**September 16, 2015**

49031-02409 Version 3

**MIL Comes ON with DTC P2646/P2651 or P2647/P2652**(Supersedes 13-021, dated February 28, 2013, to revise the information highlighted in **yellow**)**AFFECTED VEHICLES**

**2008–2012 Accord PZEV**

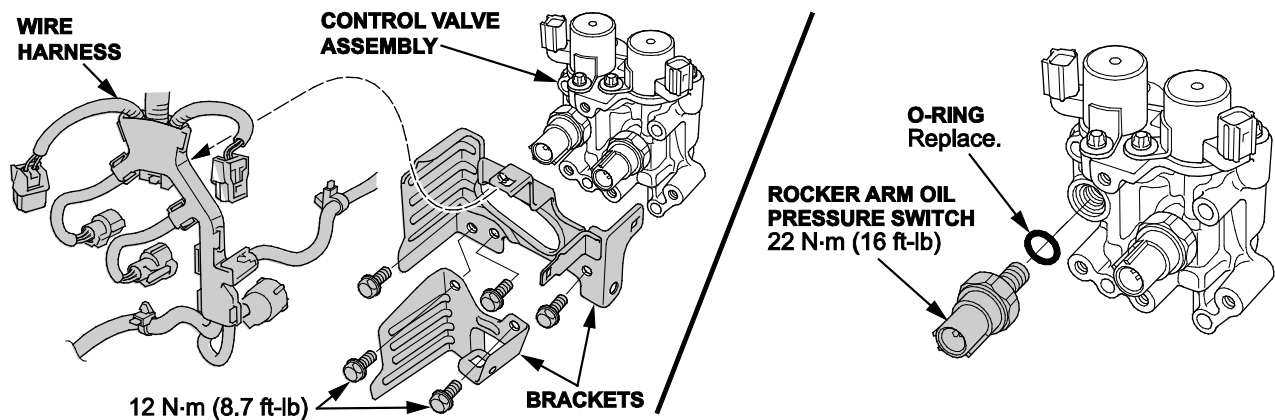
Under REPAIR PROCEDURE, illustrations in step 2 specific to 2008–12 Accord PZEV were added along with additional FRT.

2. *PZEV*: Remove the wire harness and the brackets.
3. Remove the rocker arm oil pressure switch and the O-ring:

4. Install the new rocker arm oil pressure switch and the new O-ring. Torque the switch to **22 N·m (16 lbft)**.
5. *PZEV*: Install the brackets and torque the bolts to **12 N·m (8.7 lb-ft)**, then install the wire harness.
6. Reinstall the power steering high pressure hose bracket.
7. Clear the DTC(s) with the HDS.
